# Errata Sheet MB88F332 Indigo

July 10th, 2009

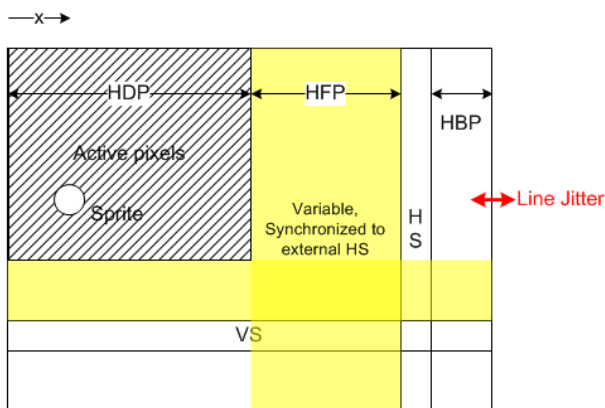
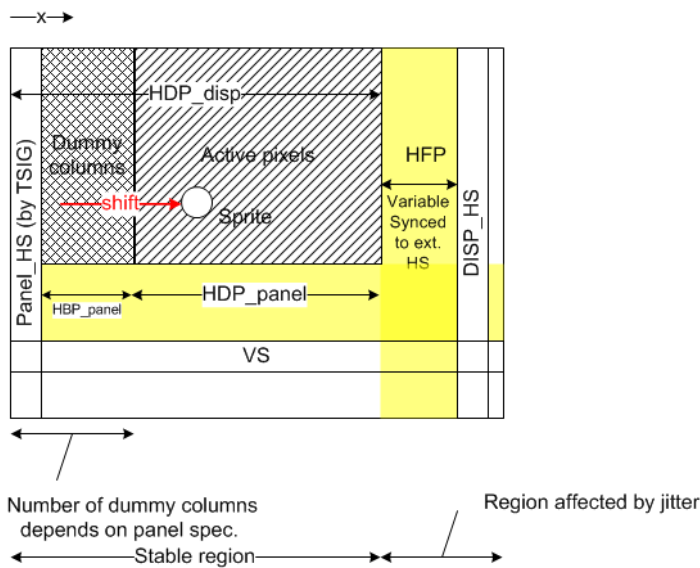
Panel output is affected by line jitter if the display controller module is used in the 'external synchronization' mode and the TCON module is simultaneously active (i.e. TCON bypass is disabled). Panel timing parameters such as horizontal back porch show a jitter of +/- 1 pixel clock period. Please note that although the jitter is physically present, it may not be visible if a panel is used that has an internal TCON (or similar logic circuitry). This is because some TCONs are able to compensate the jitter of the incoming H-sync by also evaluating the DE (Data Enable) signal.

The following two diagrams serve to clarify the problem and its workaround.

The concept behind the following workaround is to shift the h-sync pulse to a more suitable region that is not effected by jittering.

Insert dummy columns on the lefthand side of the active display area. As a consequence, all sprite coordinates or external graphic layers must be shifted to the right.

The horizontal coordinates of the TSIG module pulse generators (which influence the horizontal backporch) can now be programmed according the following equation:

This generates a stable horizontal back porch.

E8: [back to top](#)  
Signature Unit: Signature B: 'Summation Signature (pixel color values) limited for evaluation window covering column 0

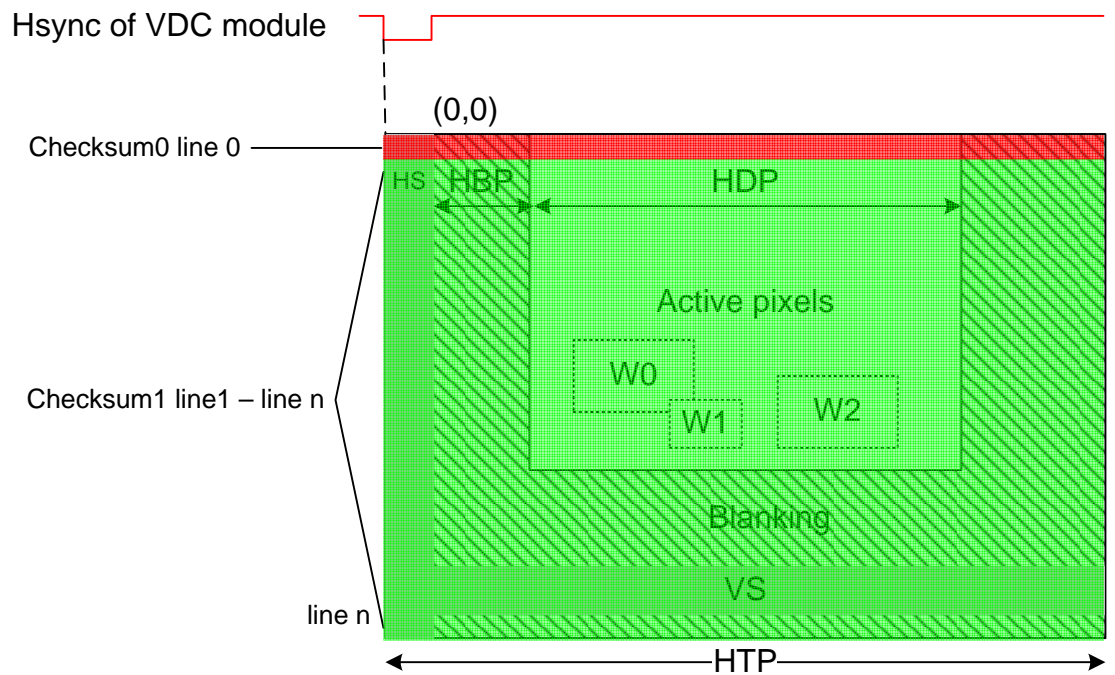
For the checksum type Signature B: 'Summation Signature' (pixel color values), the checksum is not reset at the end of the frame if the left evaluation window column is column 0.

This means that the SIG unit register `HorizontalUpperLeftW0` may not be set to 0.

Set `HorizontalUpperLeftW0` to values  $>0$ .

**Figure 1 - Example for cyclic monitoring of 3 windows**

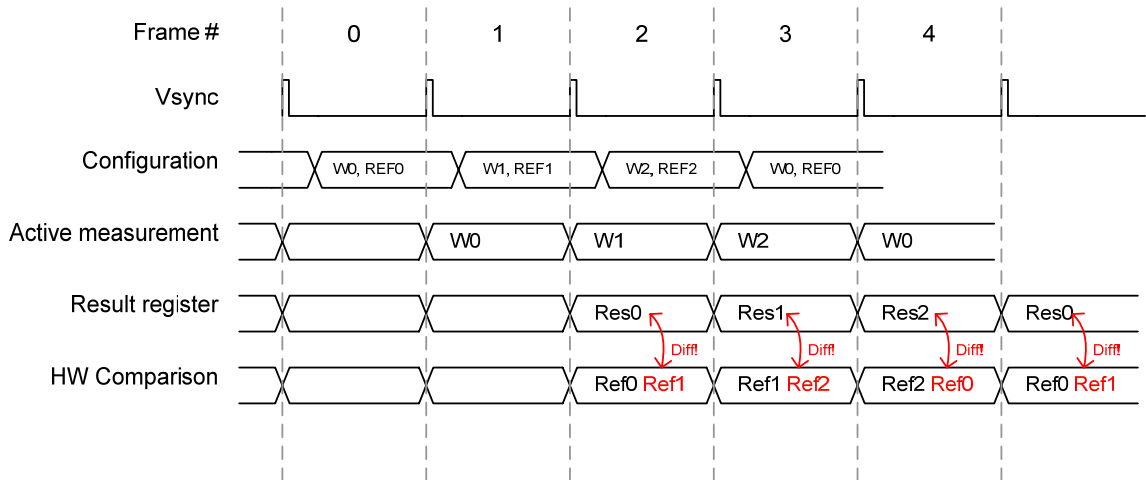
Two checksums (instead of one) are generated per frame; one covering line 0, the other from line 1 to line n (n = content of the display controller Vertical Total Raster register 'VTR' + 1). The result registers show only the result of line 0.  
Consequence: The content of line 1 to n can not be monitored directly by an external microcontroller using the result registers Signature[A|B][R|G|B]W0.

The continuous monitoring of multiple windows with different coordinates is not possible in the way described in the Hardware Manual.

The following diagram shows (in black) the specified behaviour, whereas the red color illustrates the current behavior of the chip.
